PUBLIC HEARING MEMORANDUM

SUBJECT: **Petition #241-23**, for SPECIAL PERMIT/SITE PLAN APPROVAL to demolish the existing dwelling and construct three single-family attached dwellings with dimensional waivers and parking dimensional waivers

236 Chapel Street

ZONING REVIEW MEMORANDUM

Proposed conditions

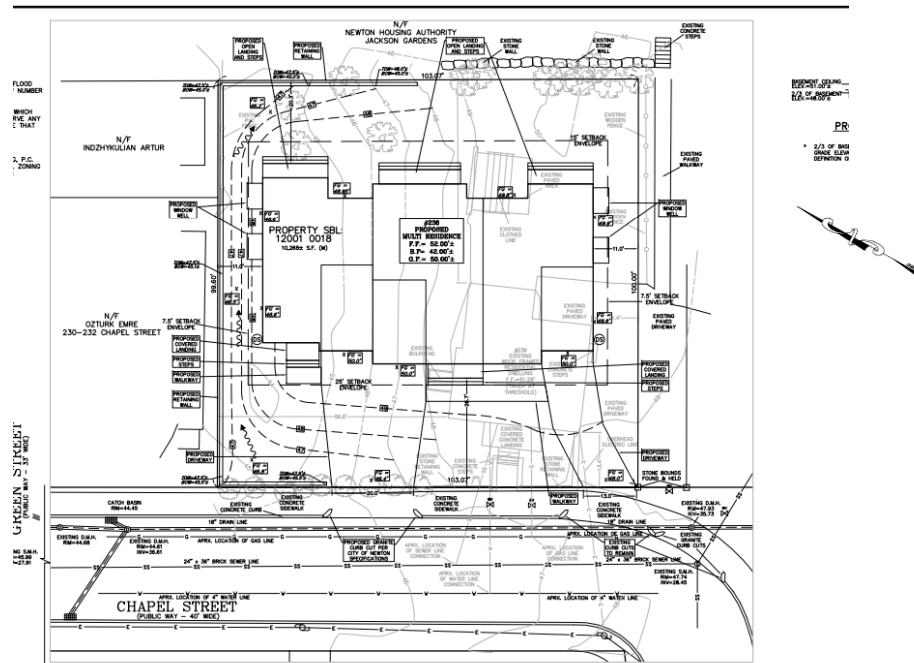
The petitioner proposes to raze the existing single-family dwelling and construct three single-family attached dwellings. Relief is required for the use of the structure as single family attached dwellings. The units will all be in one building with gables and vertical elements separating each of the residences. The building is proposed at 34.8 feet and 2.5 stories in height, where up to 36 feet and 2.5 stories are allowed by right. The lot area per unit will be 3,423 square feet where a minimum of 4,000 square feet is required, which requires relief. FAR does not apply to this project but as a point of

The existing front setback is nonconforming at 13.4 feet, and this project would increase the front setback to 26.7 feet where 25 feet is required. Both side setbacks require relief as they are proposed to be 11 feet, where 25 feet is required, and the existing side setbacks are 11.4 and 56.6 feet. The rear setback also needs relief because it is proposed to be 20.3 feet where 49.9 feet exists, and 25 feet is required.

A compliant by-right retaining wall approximately two feet tall is proposed along the left property line within the setback, extending out to portions of the front and rear setback on the left side.

Each of the three units has a private attached garage with space for one car and an additional space in one of the two driveways. The existing 13-foot-wide curb cut on Chapel Street at the south side of the site will be retained and will provide access to a paved driveway leading to the unit on the right. Because this driveway is within ten feet of the southeastern side lot line with a proposed parking stall within 20 feet of that same side lot line, a special permit is required. A second curb cut is proposed between the other two units which would be 20 feet wide and provide access to a shared driveway leading to the private garages for those two units.
